**Re: Backer Works, 5809 Jefferson St NE,
Request for Permanent C.O. –Accepted
Engineer's Stamp dated: 03-28-12, (E17/D018)
Certification dated: 07-31-12**

**Re: Backer Works, 5809 Jefferson St NE,
Request for Permanent C.O. - Disapproved
Engineer's Stamp dated: 03-28-12, (E17/D018)
Certification dated: 06-22-12**

Re: Backer Works, 5809 Jefferson NE
Grading and Drainage Plan
Engineer's Stamp date 3-28-12 (E17/D018)

ENGINEER'S SEAL	DAVID J. HESTER
BACKERWORKS MANUFACTURING LLC 5809 JEFFERSON	
GRADING AND DRAINAGE PLAN	
Hjo Grande Engineering 1000 GARDEN AVENUE, SUITE 200 ALBUQUERQUE, NM 87102	
DATE 8-22-11	SHEET 1
DATE 21103

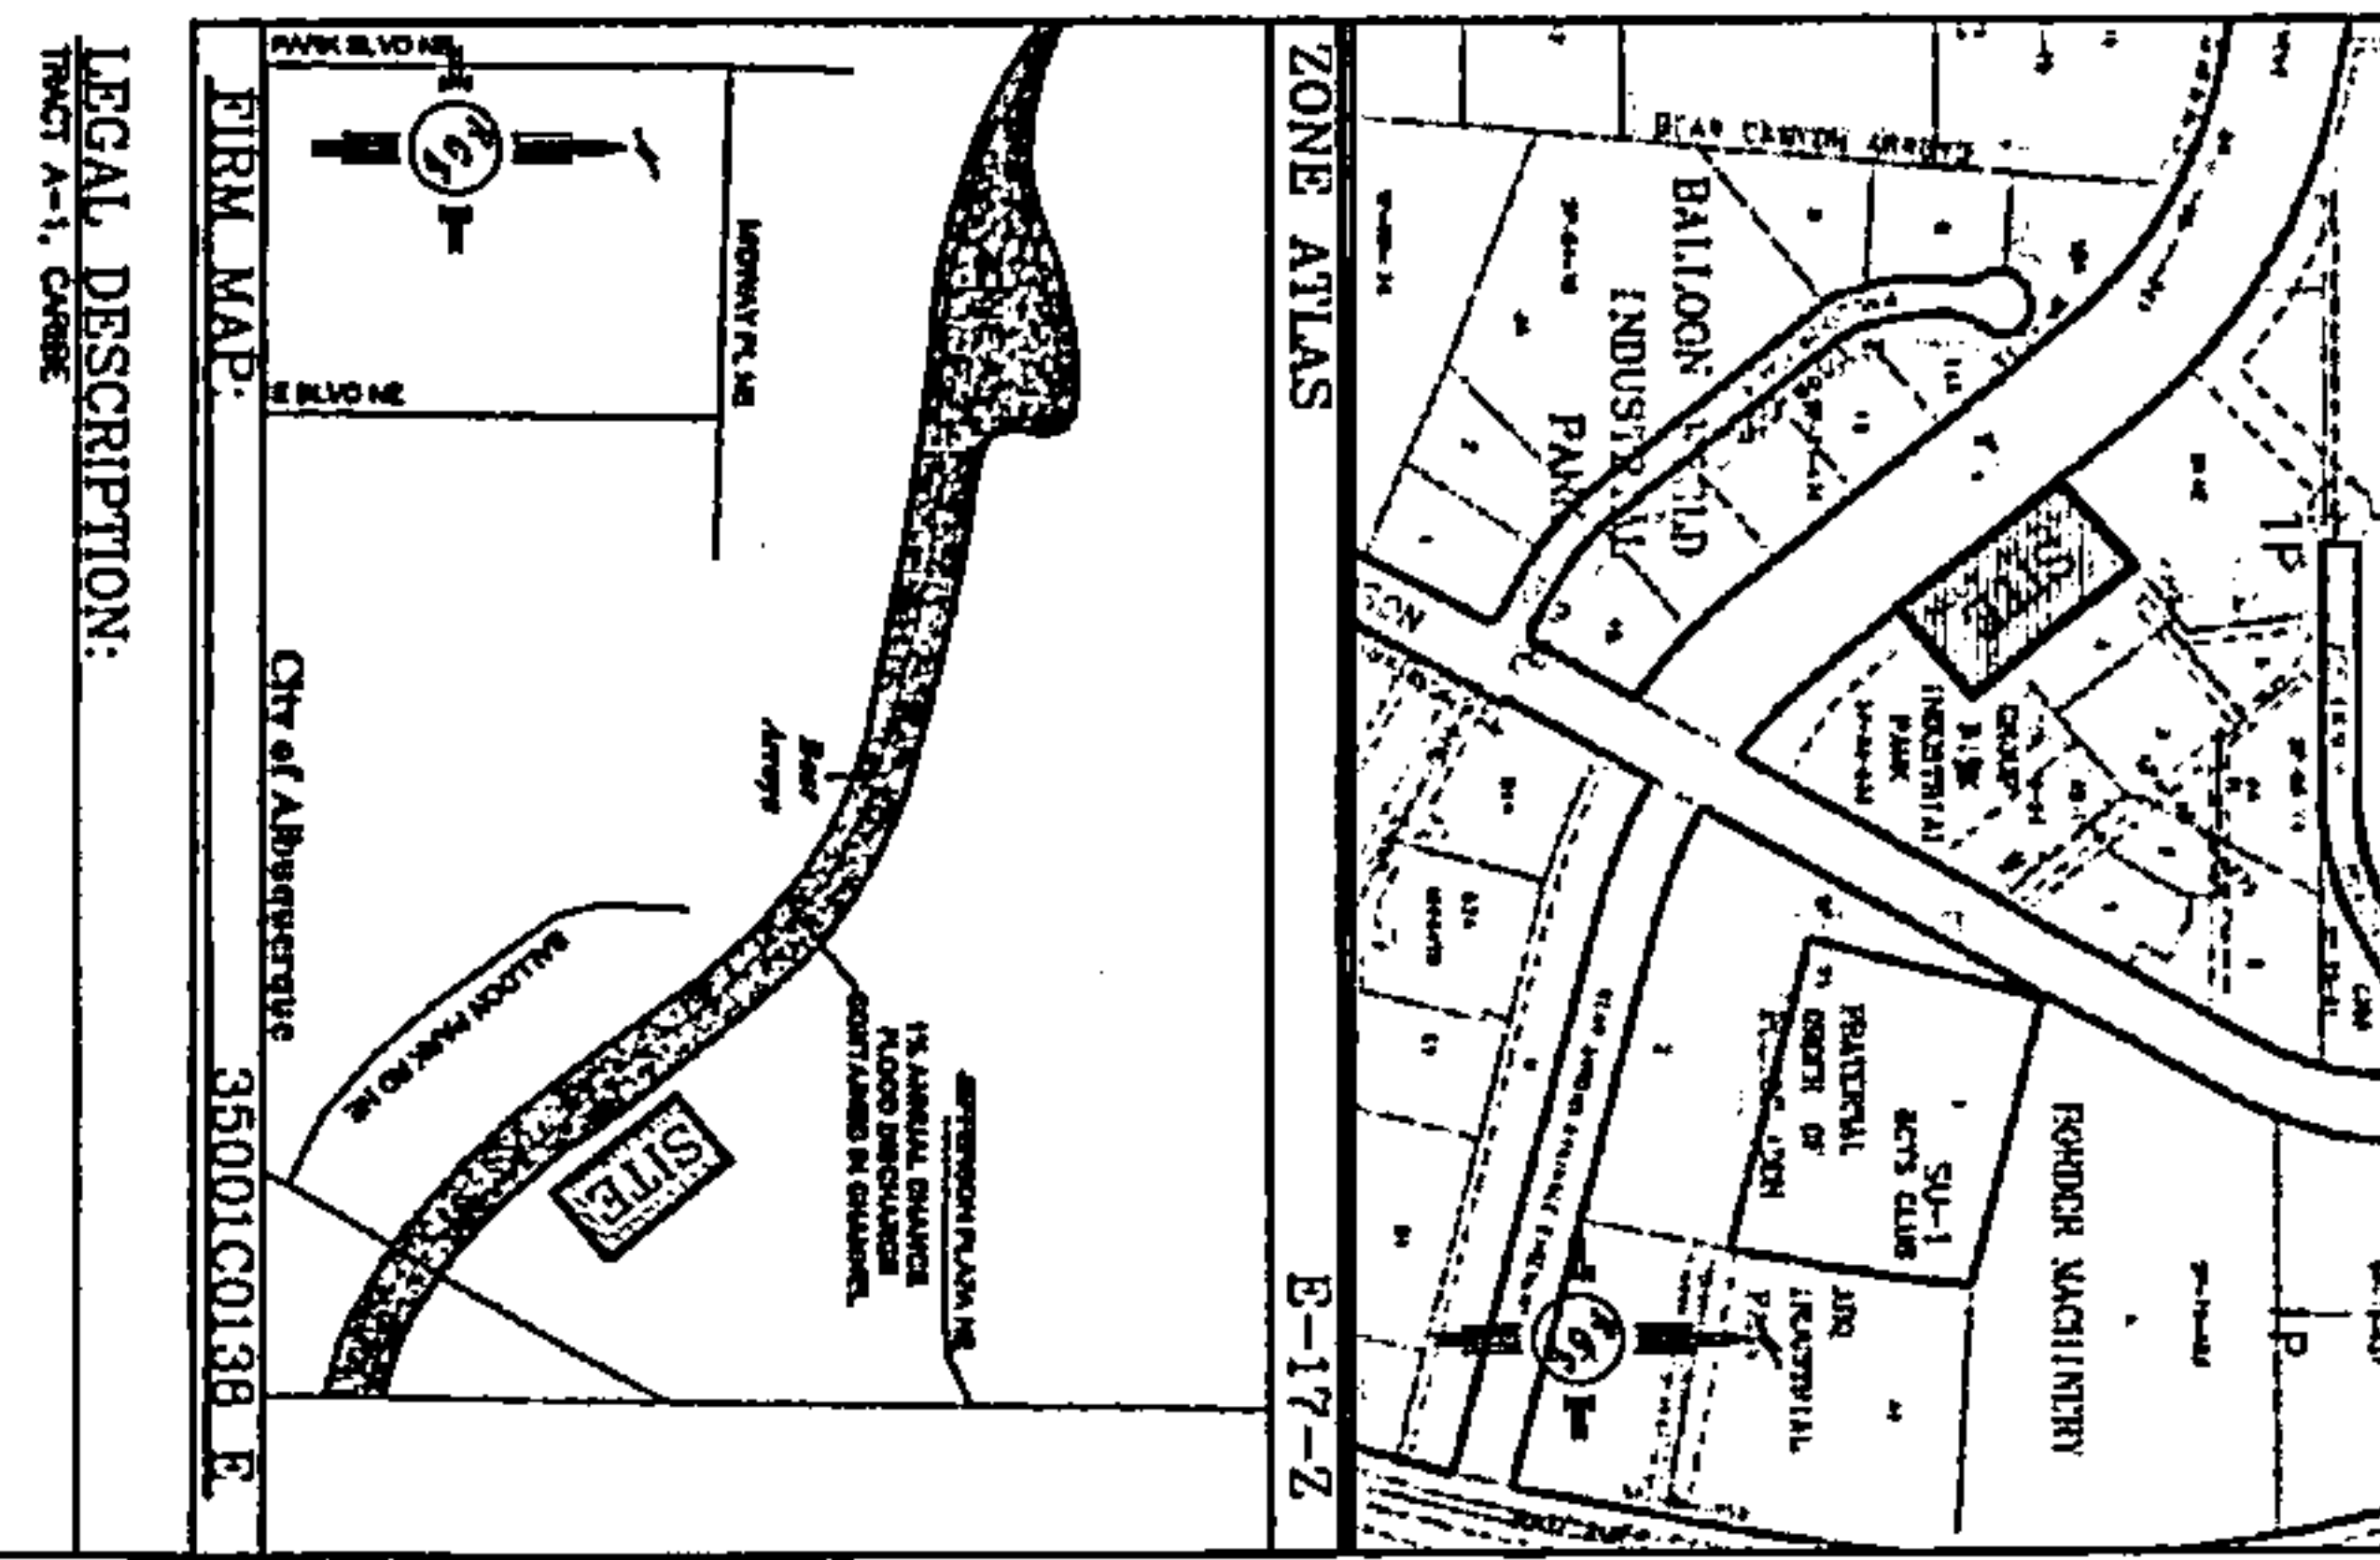
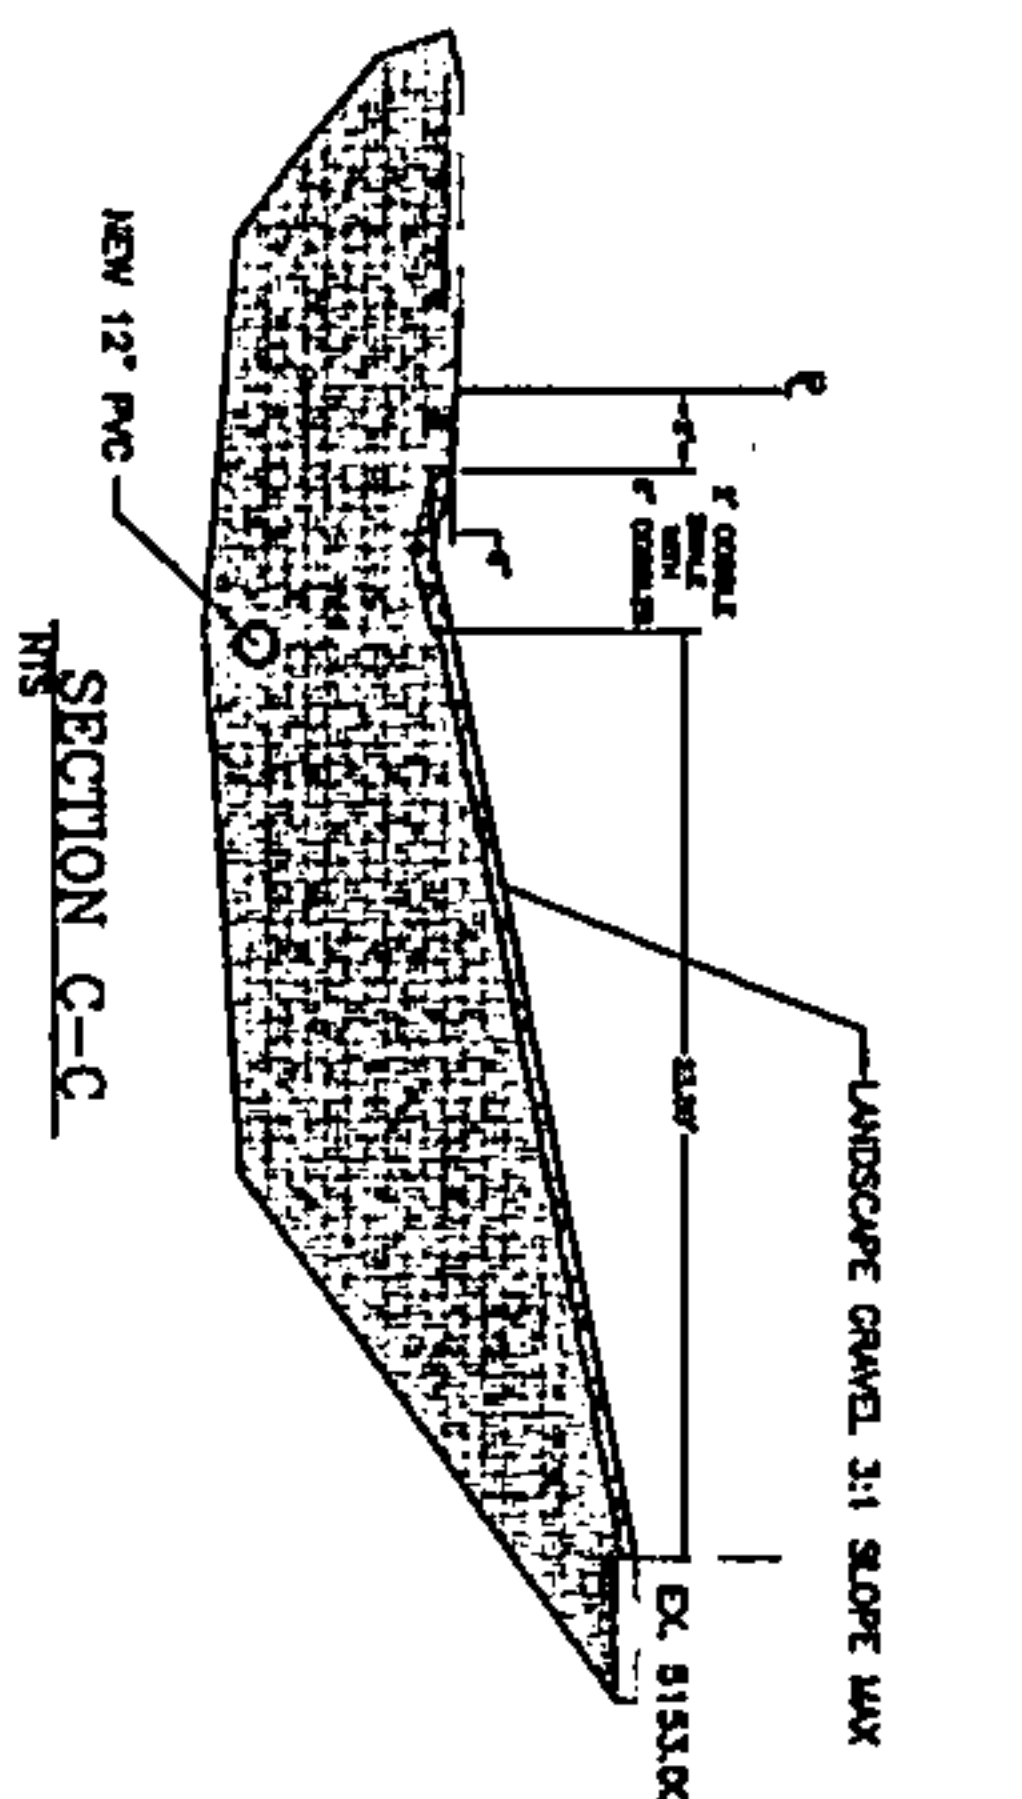
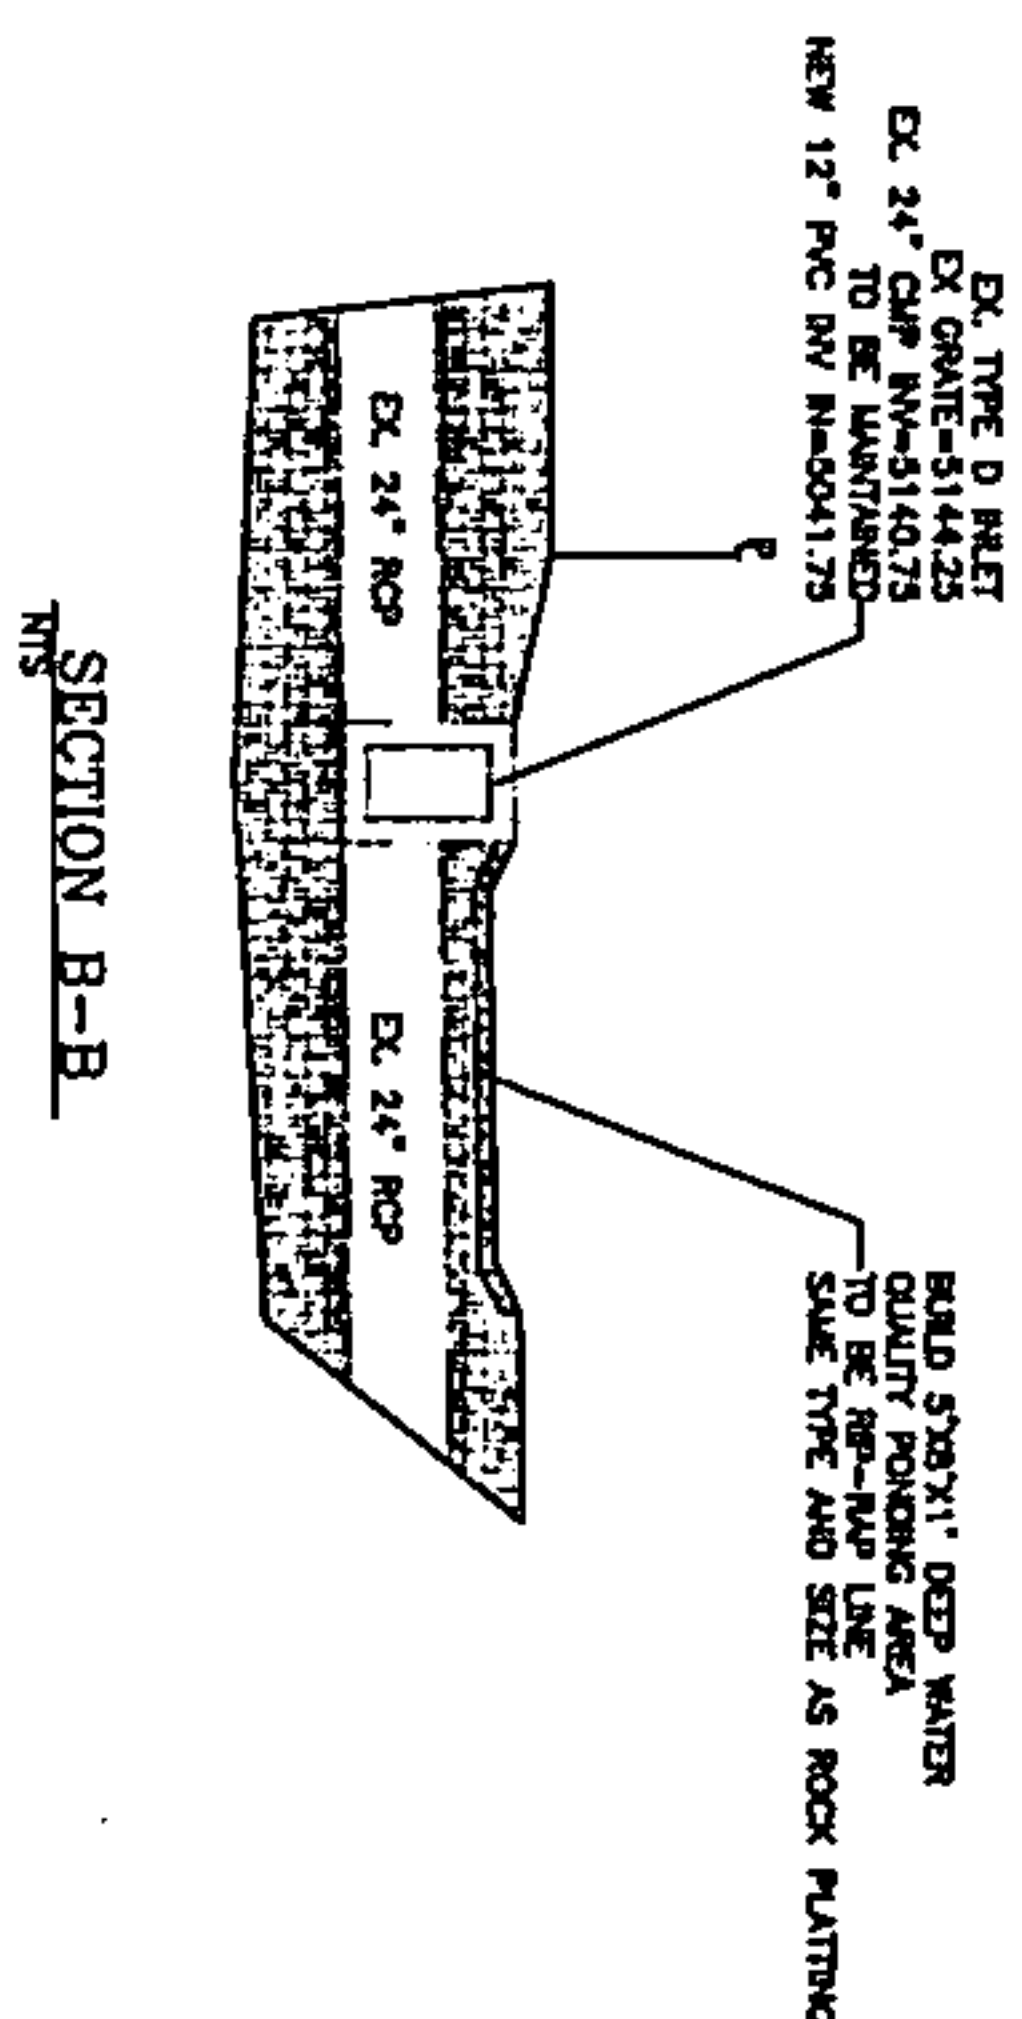
I did some research and investigation and cannot approve the referenced plan. It does not show some existing drainage features that I think should be shown. Please clarify and respond/revise/resubmit as necessary. The following items should be addressed:

1. The plat of the North Diversion Channel (NDC), Phase 4 (see attached portion of plat), shows a 60-foot east-west and 45-foot north-south private storm drain easement on the property.
2. The City Storm Facilities Maps (see attached portion) shows a 24-inch RCP outfall to the Bear Canyon Arroyo. I did not measure the pipe, but I think it is a 24-inch RCP, not a 36-inch CMP that is shown on the plan. It extends to the north to pick up runoff from adjacent properties. I verified Type D inlets marked 1 and 2 on the attached map. Inlet 3 is a slotted grate manhole that appears to be in the northwest corner of the Backerwerks property.
3. There is a low spot at number 4 full of tumbleweeds and vegetation. I did not dig it out in my field investigation. The City facilities map indicates that it might be a Type D inlet.

AMAFCA would like to see the low area around inlet 4 expanded to about 5 feet to the north to serve as a water quality ponding area. It should be lined with riprap. Also, place riprap to the property line next to the rock plating in Section A-A and from the end of the 12-inch PVC to the ponding area. If you have any questions, please call me at 884-2215.

The revised plan is acceptable to AMAFCA. I don't think we need to meet.

Lynn, I have attached the revised drawing. I have addressed your comments. The owner is pressing me to get an approval soon. He was a line backer for the New York Giants about 10 years ago, so I am extra motivated to keep him happy. Would you be able to review this, He asked if I could set up a meeting with you to go over. The comments were pretty straight forward. The easment you reference is on a lot west of us, and does not impact our site. The storm drain inlets have been shown and the water quality pond has been added. Please let me know if this is ok and if a meeting is warranted. Thanks
